UNITED STATES
DEPARTMENT OF THE INTERIOR
BUREAU OF LAND MANAGEMENT

SUNDRY NOTICES AND REPORTS ON WELLS
Do not use this form for proposals to drill or to re-enter an abandoned well. Use Form 3160-3 (APD) for such proposals.

8. Well Name and No.
Lybrook E27-2306 01H

In an effort to alleviate any confusion Encana Oil & Gas (USA) Inc. (Encana) wishes to do the following in relation to the Lybrook E27-2306 01H oil well:

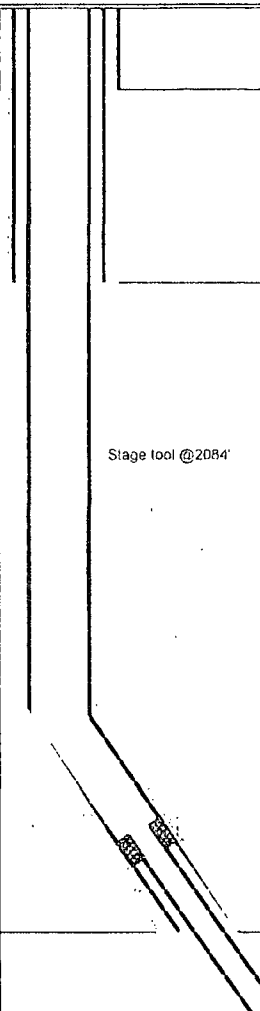
Encana Oil & Gas (USA) Inc. (Encana) would like to adjust the bottom hole location, and 7" casing setting depth and cement program for the Lybrook E27-2306 01H oil well.

Encana's casing program will contain the following changes: 7" Intermediate casing: from 6,450' MD to 5,832.

These revisions change the total depth (TD) of subject well to 5,563' TVD/10,539' MD from 5,560' TVD/11,171' MD

WELL LOCATION AND ACREAGE DEDICATION PLAT

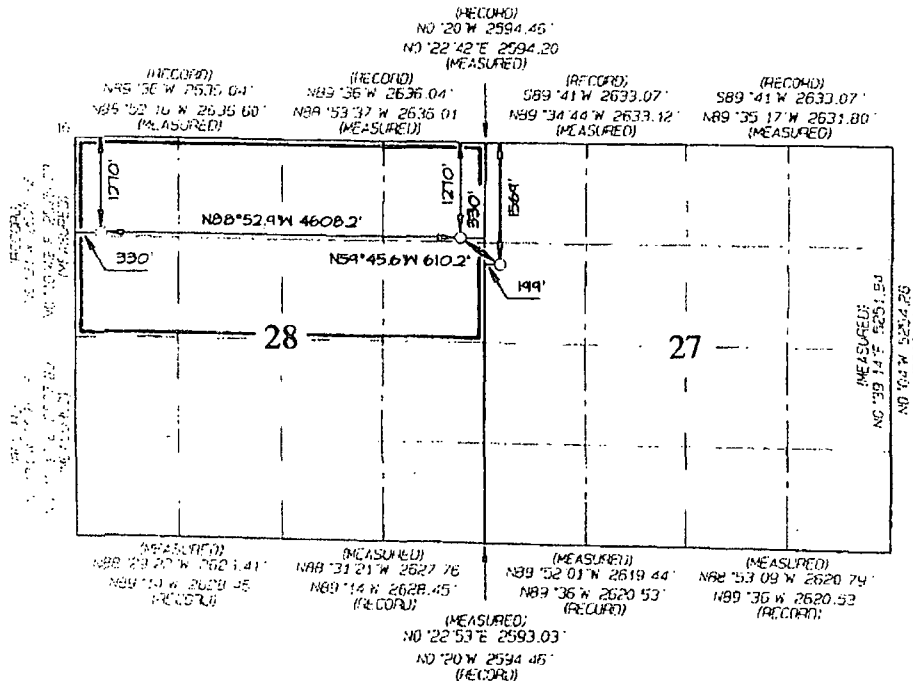
The new bottom hole location will be 1270' FNL, 330' FWL Section 28, T23N, R6W.

Section	Range	Lot	Feet from the	North/South Line	Feet from the	Last/Next Line	County
28	23N	6W	1270	NORTH	330	WEST	SANDOVAL
